PERMIT AMENDMENT MAP

FOR GROUND WATER PERMIT APPLICATIONS G-17107 & G-17365 ANDY ROOT

TOWNSHIP 22 SOUTH, RANGE 33 EAST, SECTION 30, W.M. TAX LOTS: 303 & 1800

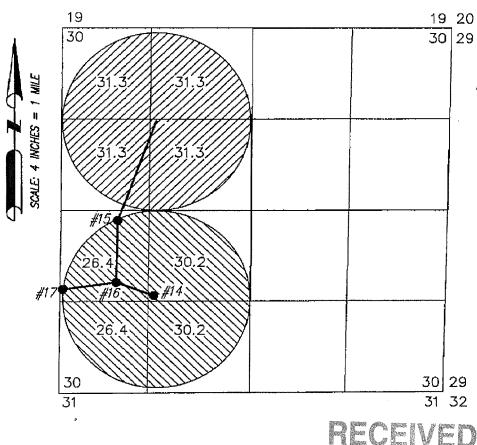
The map should have listed Well 14 in the NE of the SW of Section 30. The assessor's map lists the distance from the SW corner of the section to the W 1/16 corner as 1307.2 feet. I've attached a revised map correcting the called out 1/16 corner of the section where the well is supposed to be.

EXISTING WELL IN THE NE 1/4 OF THE SW 1/4 OF SECTION 30 LOCATED 1254 FEET NORTH AND 1240 FEET EAST FROM THE SW CORNER OF SECTION 30, TOWNSHIP 22 SOUTH, RANGE 33 EAST, W.M., HARNEY COUNTY, OREGON
